CWE 2210373.03r

Subject: Revised Response to DSD-Geology Review Comments, Project Issues Report 1099348, Proposed Single-Family Residence, APN 346-831-44, Ruelle Nicole, La Jolla, California

References: 1) City of San Diego, DSD Geology Review Comments, Project Issues Report 1099348, dated October 11, 2023.
2) Sebastian Mariscal Studio, Architectural Plans, Hermann House, 2538 Ruelle Nicole, La Jolla, CA 92037, dated August 8, 2023.
3) K&S Engineering, Inc., Conceptual Grading and BMP Plans, Hermann House, Lot 25 Montoro, undated.
4) Christian Wheeler Engineering, Report of Preliminary Geotechnical Investigation, CWE 2210373.02, April 17, 2023.

GEOLOGIC CROSS SECTION A-A'

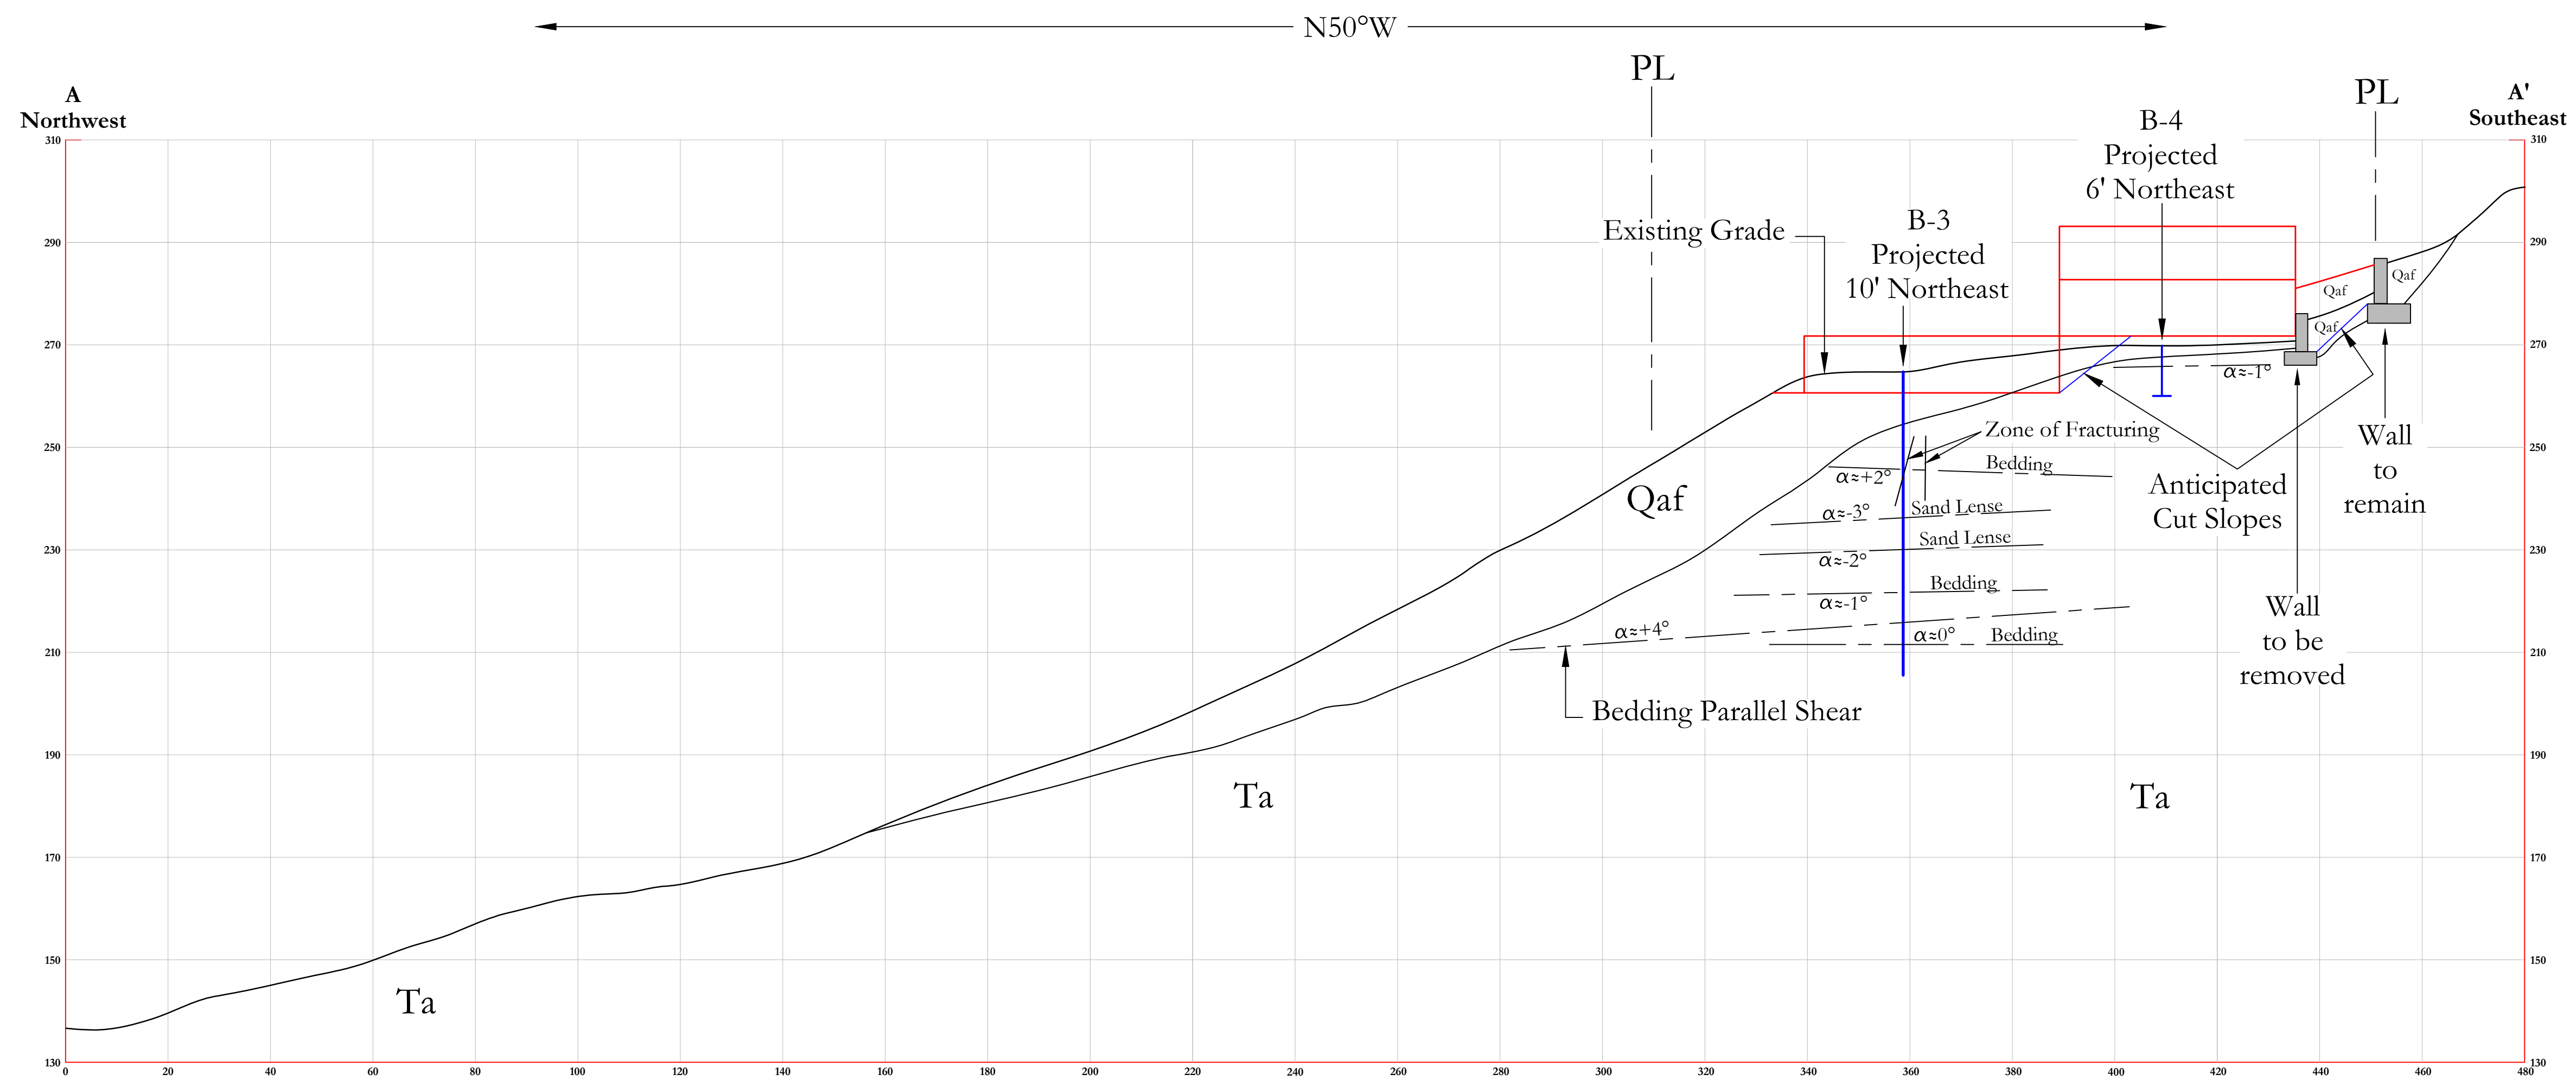
City Comment 00022: Update the existing cross-section to include temporary slopes.

City Comment 00025: Seismic (pseudo static) slope stability is not discussed in the geotechnical report. Please provide slope stability analysis.

CWE Response: Geologic Cross section A-A' has been updated to show the anticipated temporary cut slopes and is included herein as Plate No. 2.

CWE Response: Appendix B of this report presents the results of our pseudo-static stability analysis of the proposed site topography along geologic cross section A-A' (see Plate No. 2). The results of this analysis indicate that following the proposed construction, including recommended shear pin installation, the slope that descends to the northwest of proposed improvements will demonstrate a minimum factor-of-safety against pseudo-static failure of 1.1, which is the minimum that is generally considered to be stable.

GEOLOGIC CROSS SECTION B-B'

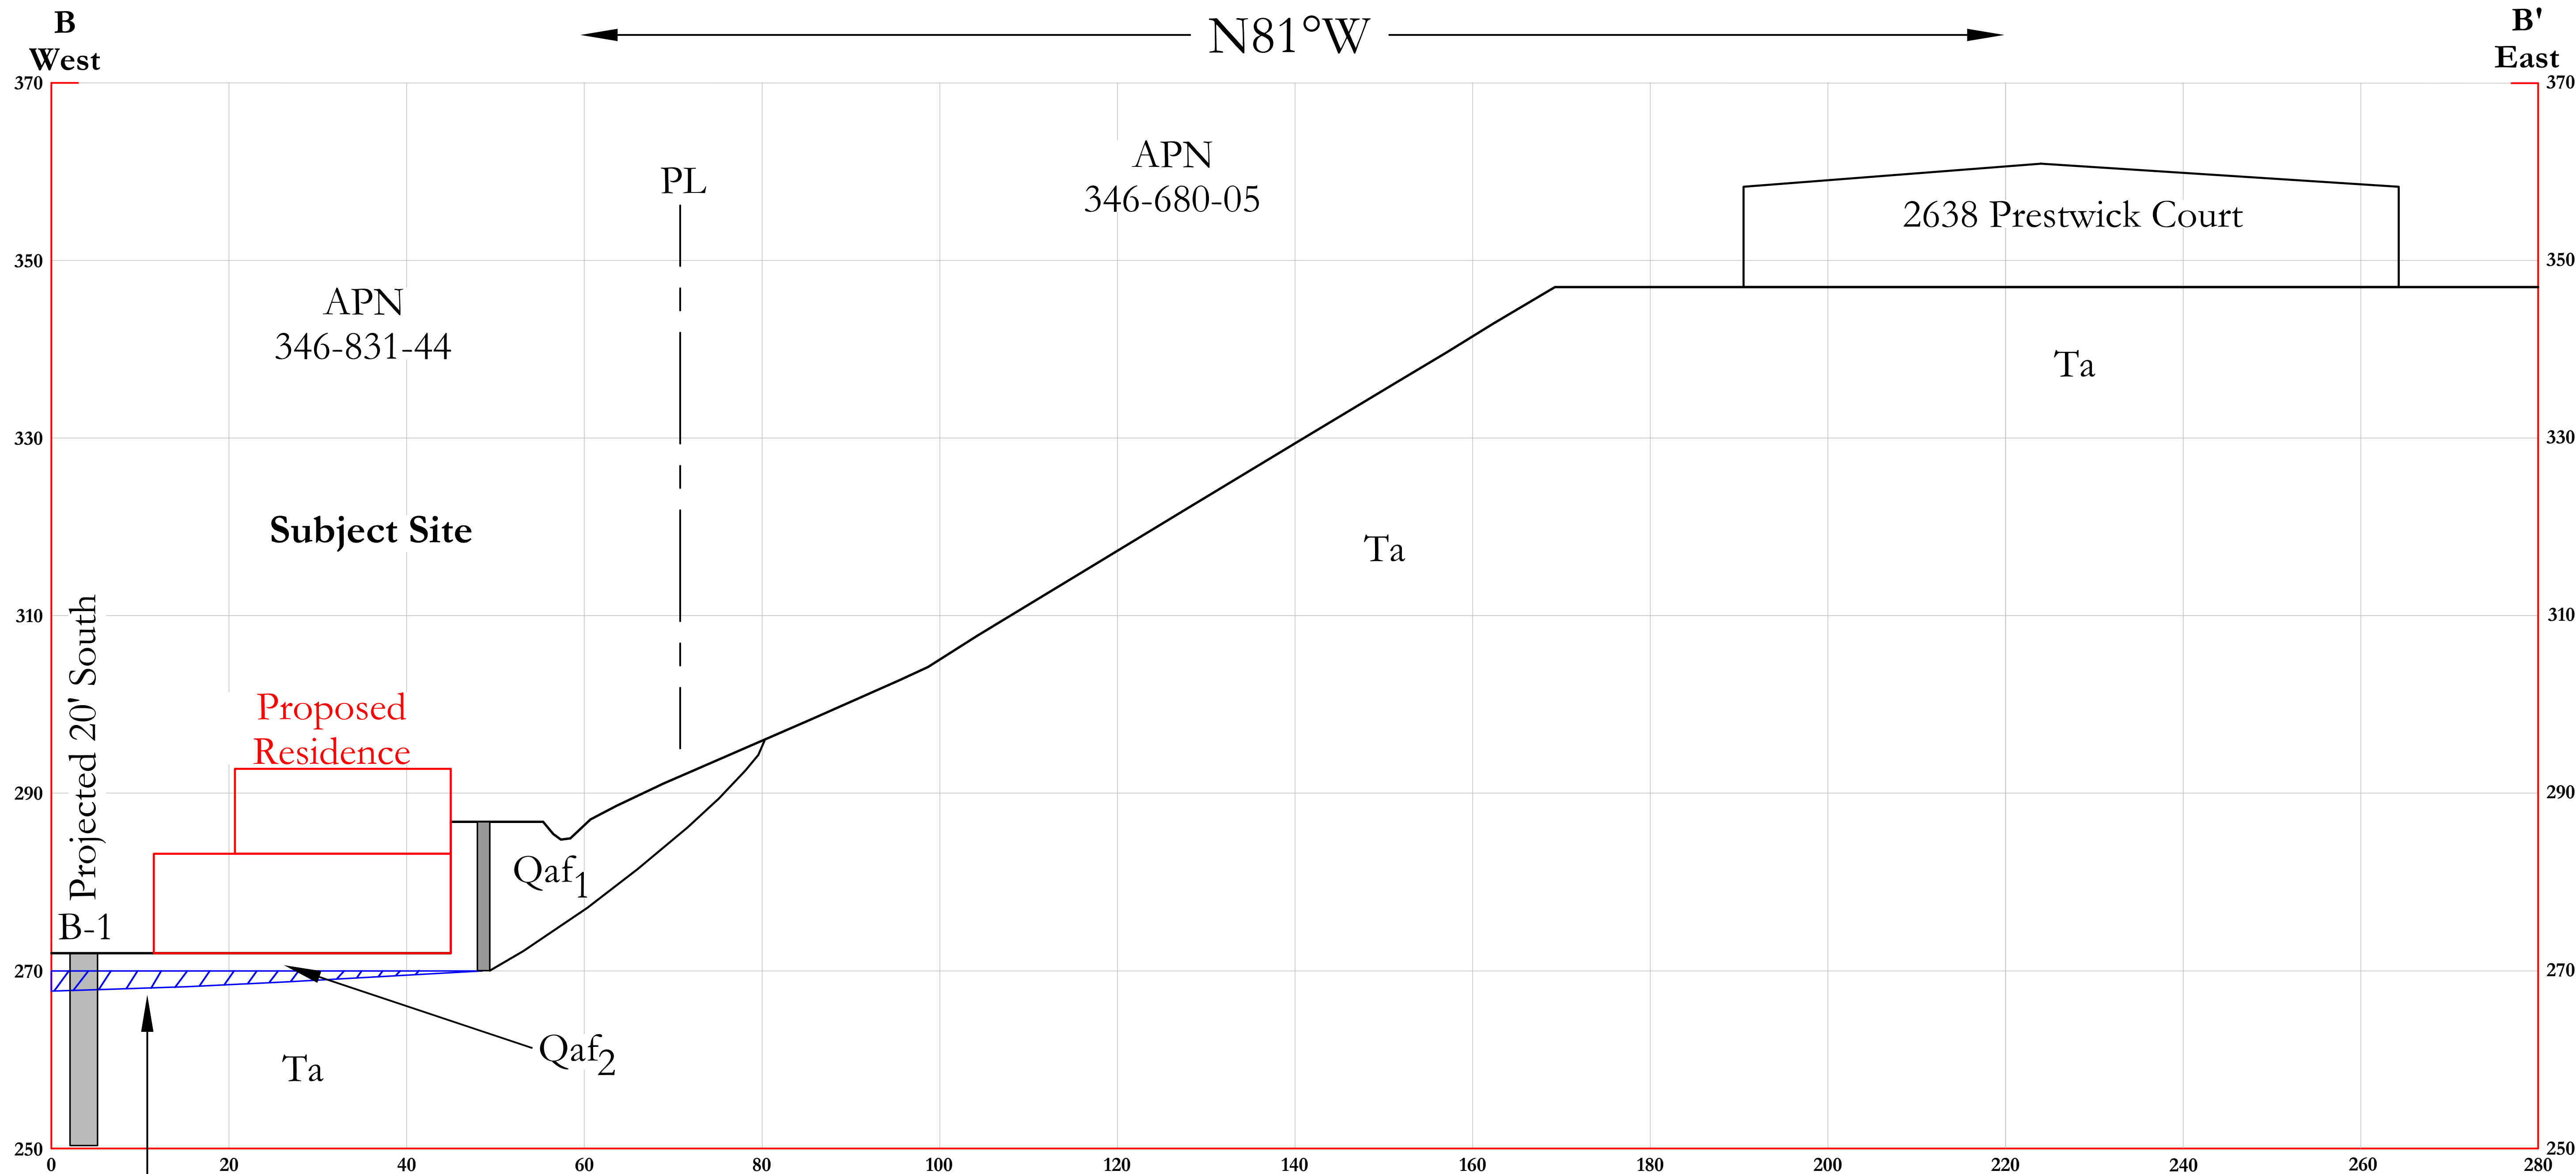
City Comment 00020: Provide an additional east-west representative geologic/geotechnical cross section that shows the existing eastern slope and proposed grades, existing retaining wall, distribution of fill and geologic units, the anticipated area of the proposed excavation, and temporary slopes. The cross-section should be scaled and extend beyond the property lines to show the adjacent structures.

CWE Response: A geologic cross section that depicts the existing eastern slope and proposed grades, existing retaining wall, distribution of fill and geologic units, the anticipated area of the proposed excavation, and temporary slopes is presented on Plate No. 3 of this report.
